UNITED STATES PATENT AND TRADEMARK OFFICE

APPLICATION NO.	FILING DATE	FIRST NAMED INVENTOR	ATTORNEY DOCKET NO.	CONFIRMATION NO.
10/736,094	12/15/2003	William E. Woollenweber	2943/012	3290

Office Action Summary

DETAILED ACTION

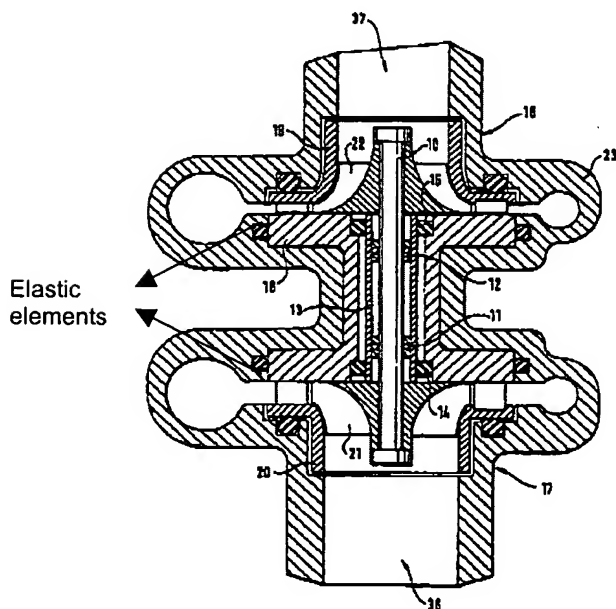
Gutknecht discloses a turbocharger for an internal combustion engine, comprising:

a rotating assembly comprising a turbine wheel (30) and a compressor wheel (22) carried at the opposite ends of a shaft (24) (See Figure); and

a stationary housing (12, 14, 16) comprising an exhaust gas volute (28) for directing engine exhaust gas through said turbine wheel (30) to rotate the rotating assembly, a compressor casing (14) for collection of compressed air from the compressor wheel (22) and a bearing housing (12) (See Figure, and Column 1, lines 44-54); a bearing system for rotatably carrying said rotating assembly within the stationary housing (38, 40), said bearing system comprising an elongated bearing carrier (38), and a pair of ball bearings (40), one ball bearing (40) being axially spaced and carried by the elongated bearing carder adjacent each of its ends, said pair of ball bearings being engaged with said shaft

(24) and rotatably carrying said rotating assembly within said stationary housing
(See Figure, Column 1, lines 65-68, and Column 2, lines 1-9);

wherein the bearing housing (12) contains an annular coolant water passage (via 72, 74, 56, 73, 75) that communicates with the outside surface of the elongated bearing carrier and has an inlet (72, 74) and outlet (73, 75) for admitting and expelling engine coolant (See Figure, Abstract, Column 2, lines 27-68, and Column 3, lines 1-12).

However, Gutknecht fails to disclose an elongated bearing carrier being removably supported by a plurality of elastic elements between the elongated bearing carrier and said bearing housing, wherein said removable elongated bearing carrier has cylindrical outside surface with a peripheral O-ring groove form on each side of said one surface, and said elastomeric bands are O-rings seated in said peripheral grooves; and the bearings being anti-friction ball bearings.
